**City of Portales  
Blackwater Well Field  
Well Equipping Phase 2**  
ITB#: 2021-11-14  
WTB 5104-WPF

**ADDENDUM NO. 2**

December 10, 2021

SHEET 14 OF 15  
 DWG NO. E-5  
 JOB NO.  
 DB18.1281

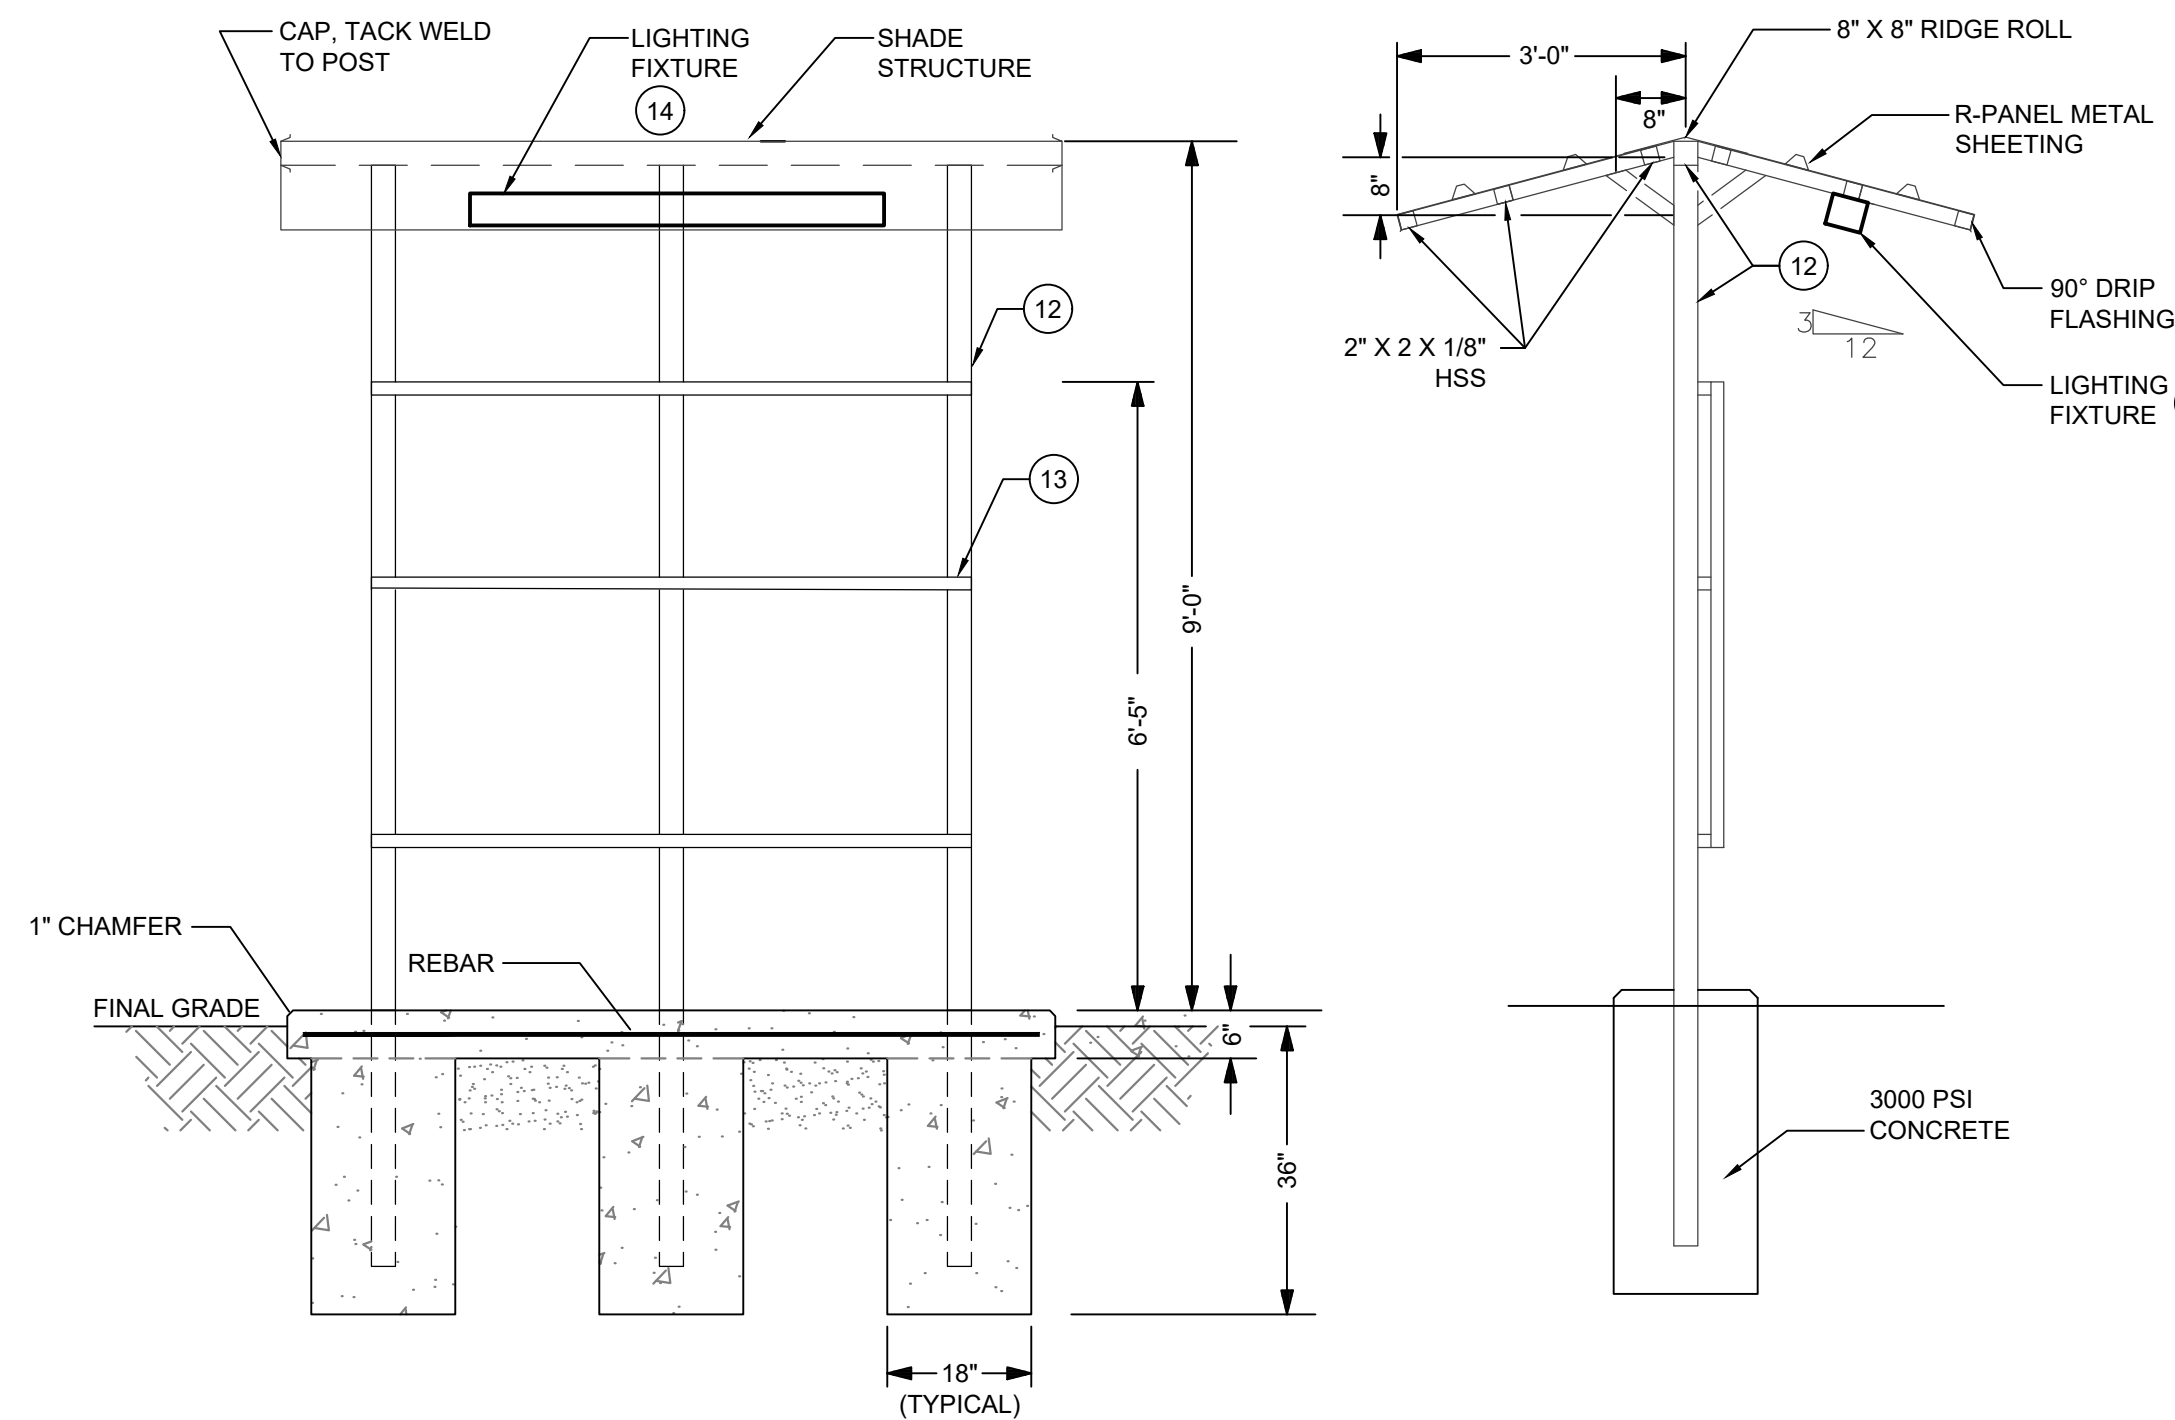
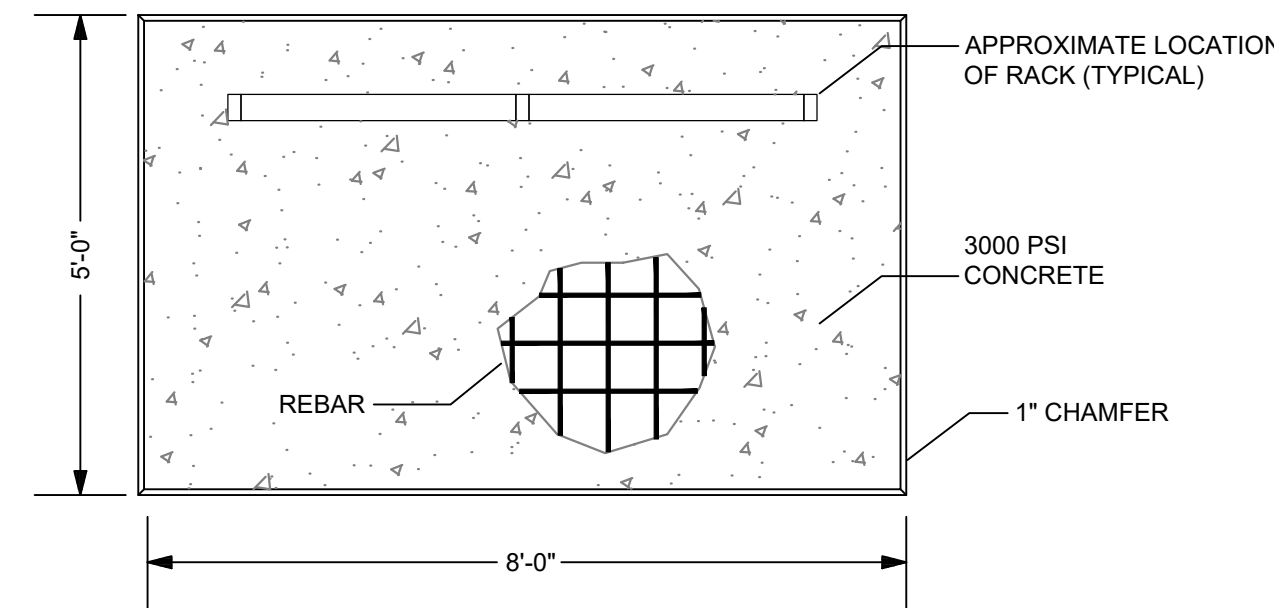
1. On the SCADA drawings for well B5, we are missing something to replace the cable from the existing pole that has 3 each 120 degree sector antenna and 1 dish to the new site. *Drawings E-3 and E-5 have ben revised to address this issue.*

Revised sheets E-3 and E-5 are attached.

23. EXTEND COMMUNICATION WIRING IN CONDUIT FROM SENSOR TO RTU.
24. EXTEND OUTDOOR RATED, ANTENNA UBIQUITI ETHERNET CABLES (WITH RJ45 CONNECTORS AND GROUND WIRE) IN CONDUIT FROM RTU TO POLE MOUNTED ANTENNA. LENGTH AS REQUIRED. PROVIDE AND INSTALL 1" CONDUIT WHERE REQUIRED.
